**SECTION 00 90 01
BIDDING AND CONTRACT REQUIREMENTS
ADDENDUM NUMBER (04)**

Issued: May 6, 2024

Bid 24-032 Elgin Sports Complex Expansion

Architect's Project Number: 14106

CU-103

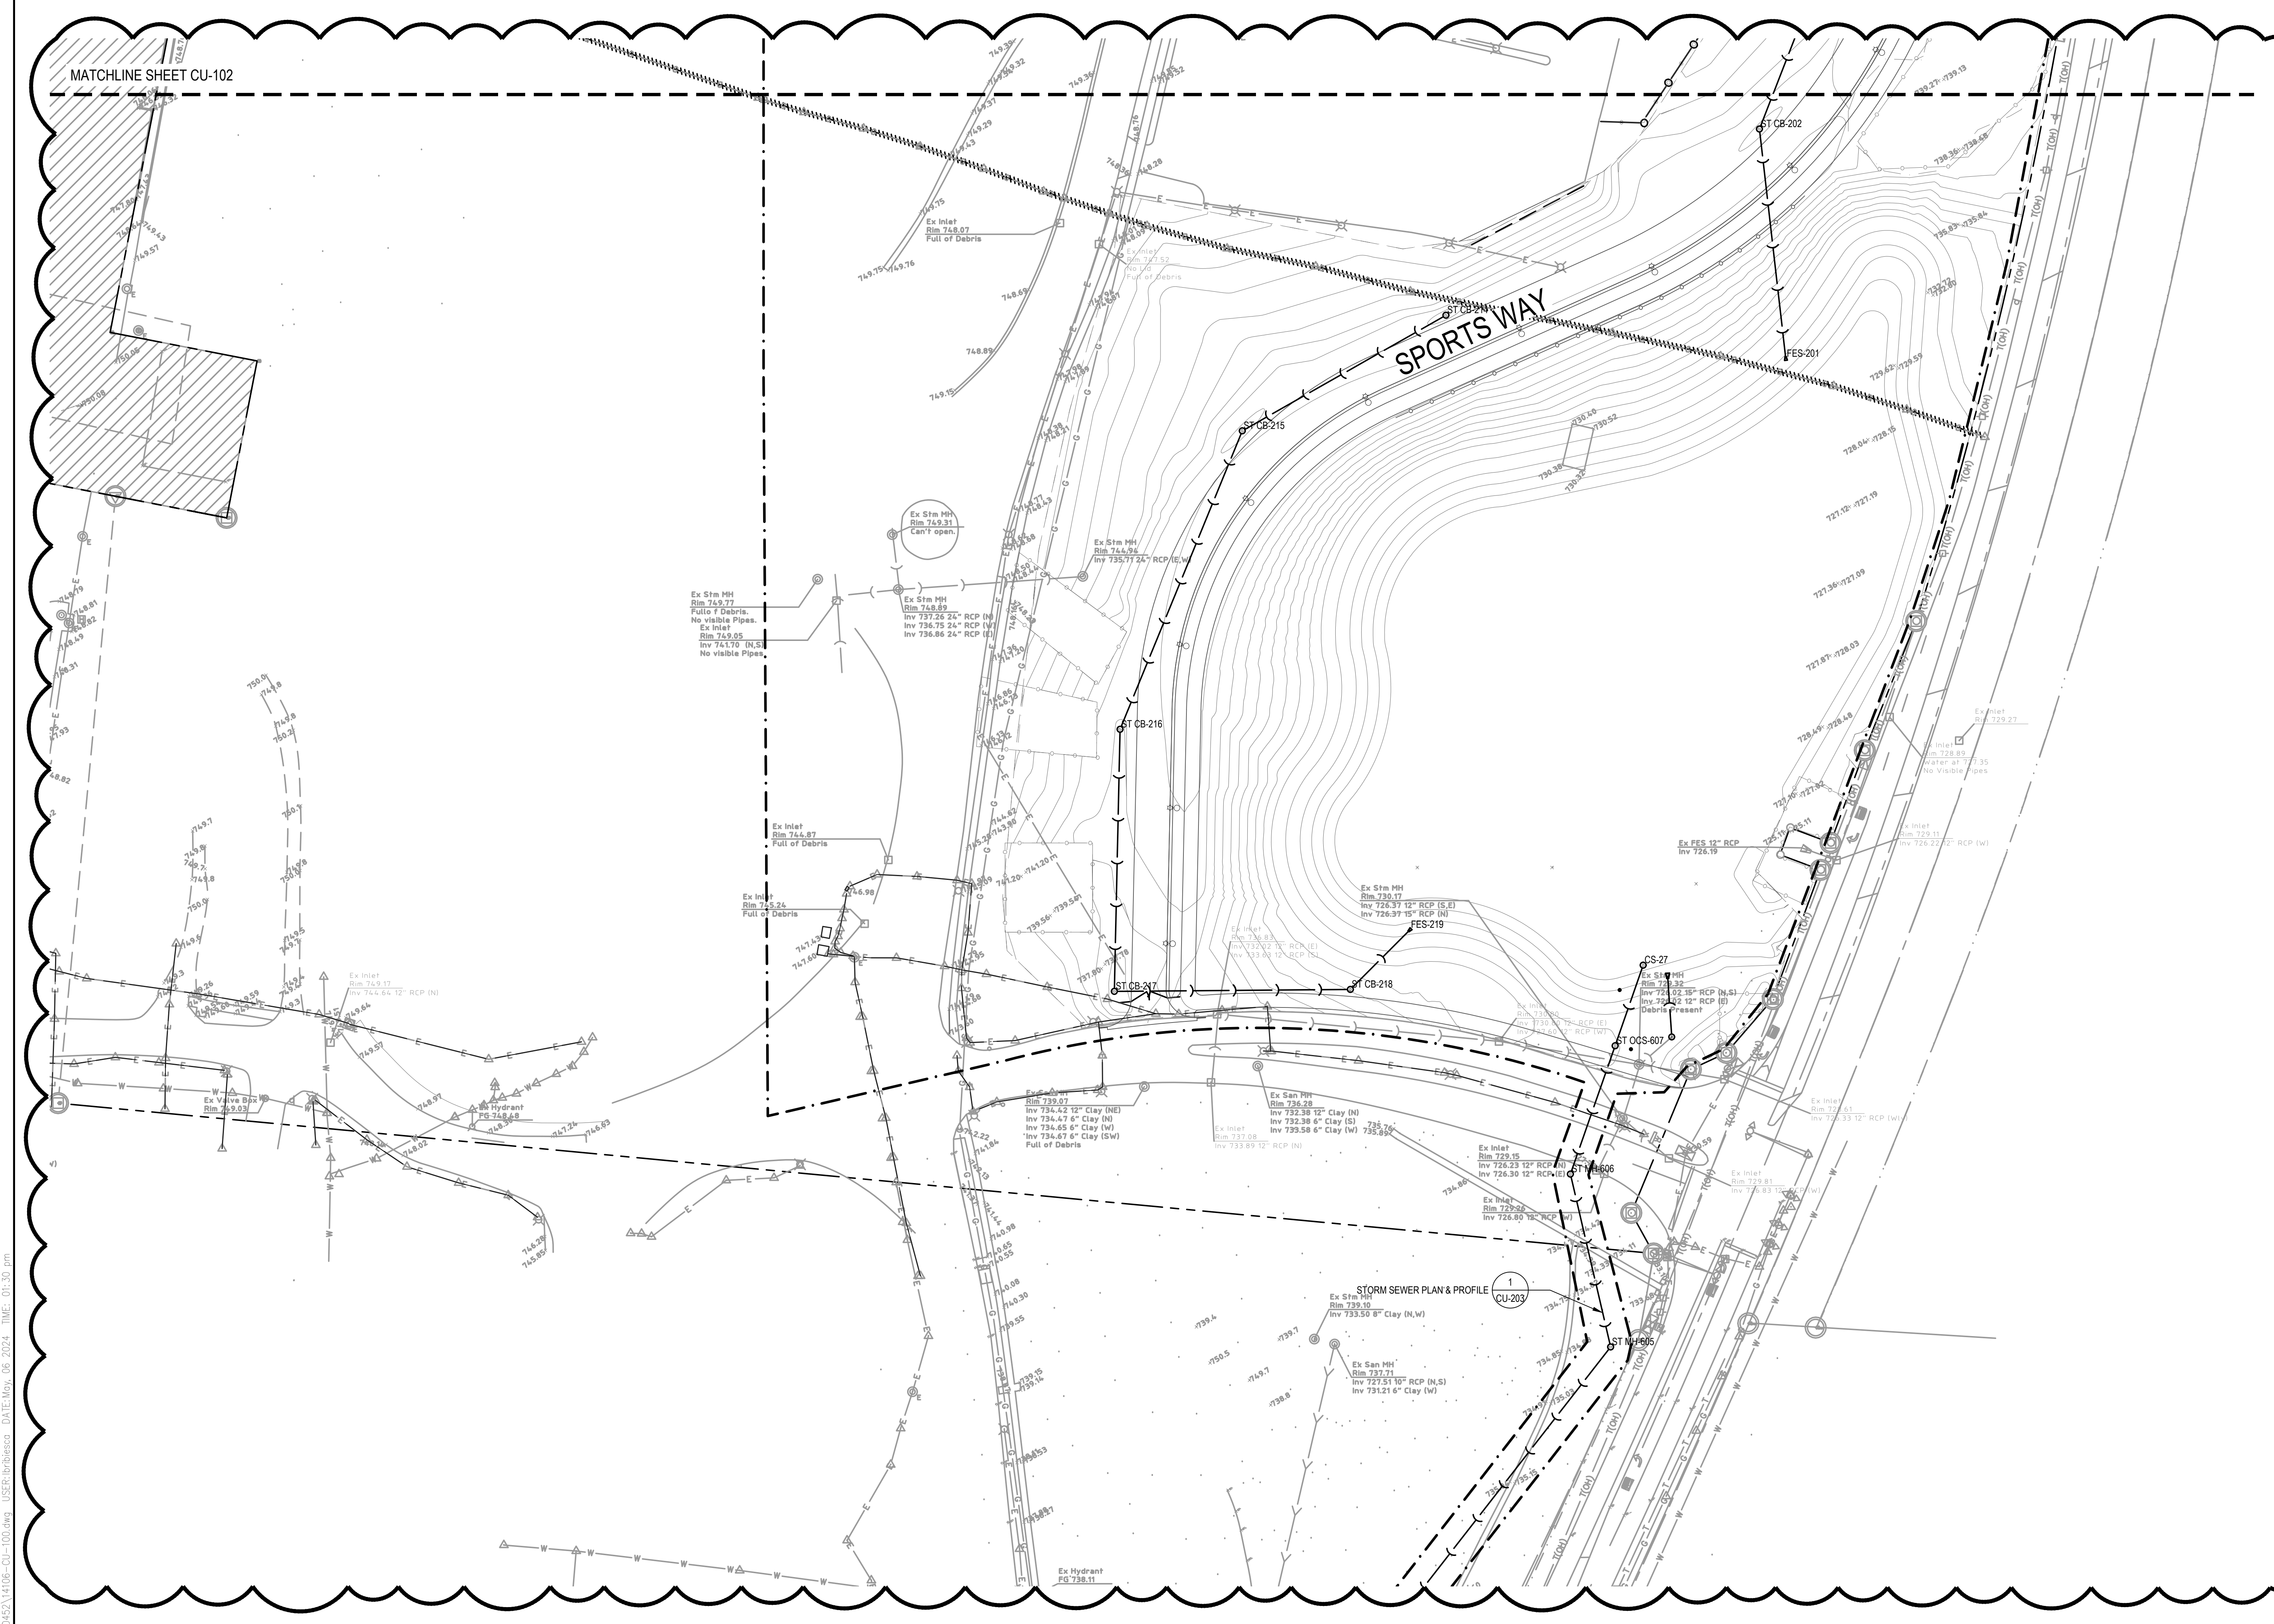
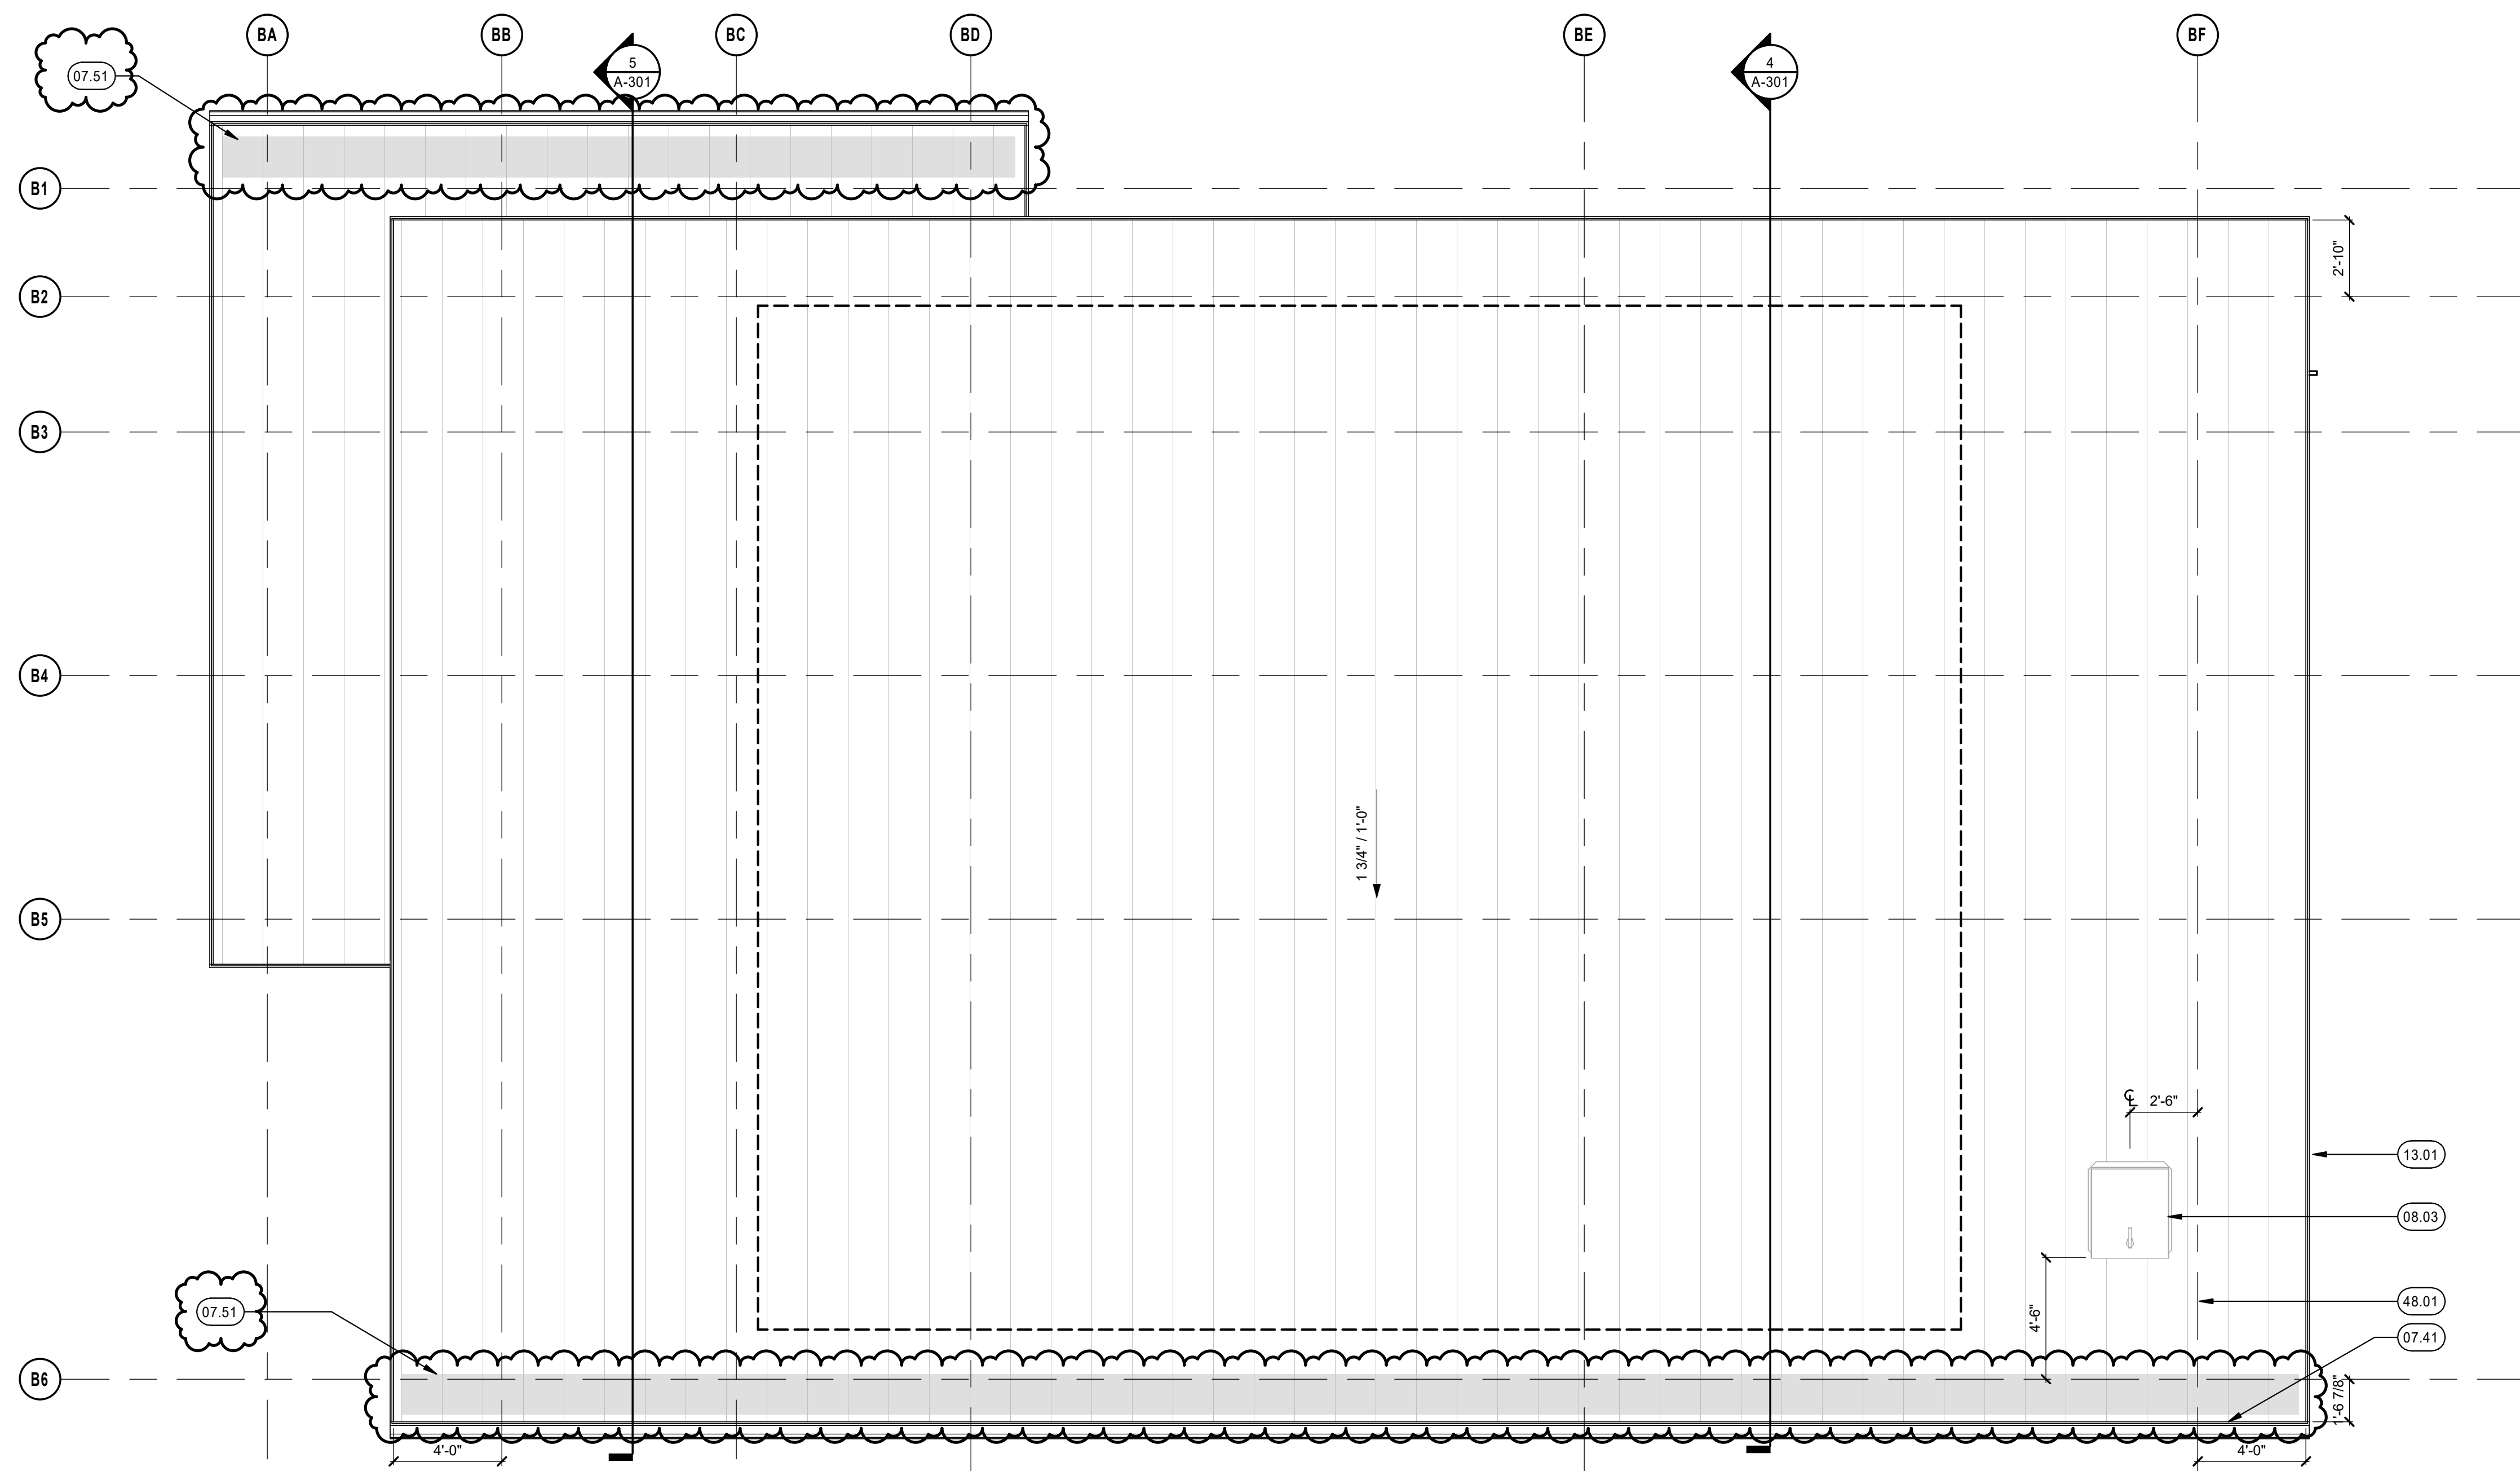
2. Description: On pages CU-101 Thru CU-103 the storm structures are shown but not labeled with any sizing, description, rim, invert or frame and lids. Some structures have the type of structures, some have everything, and some are not labeled. The Sanitary structures are all called out on pages CU-204 & 205. CU-206 is labeled Watermain Plan and Profile and shows some storm structures but not all. Will there be a revision including the structure sizing with rims, inverts, frames and lids? **See updated CU sheets in Addendum 4**

1. CU-100 through CU-103 – UTILITY PLAN: updates to storm drain, water and sanitary systems as indicated on the plans. Additions include control structures to bioswale facilities and Detention Ponds A & B, addition of culvert to convey runoff north of Sports Way to Detention Pond A, removal of 1 section of mainline storm drainpipe (AREA C) and extension of existing storm drain system that connects to Detention Pond B.
2. CU-201 through CU-203 – STORM SEWER PLAN AND PROFILE: updated to address revisions to the design layout, and to include pipe materials.
3. CU-208 through CU-214 – STORM SEWER PLAN AND PROFILE: added profiles to provide design information for portions not previously released.
4. New Sheet - ALT-200 - ALTERNATE 2 - ATHLETIC FIELD 3 IRRIGATION (See sheets issued in Addendum 3)
5. New Sheet - ALT-201 - ALTERNATE 8 - CORE AREA IRRIGATION (See sheets issued in Addendum 3)
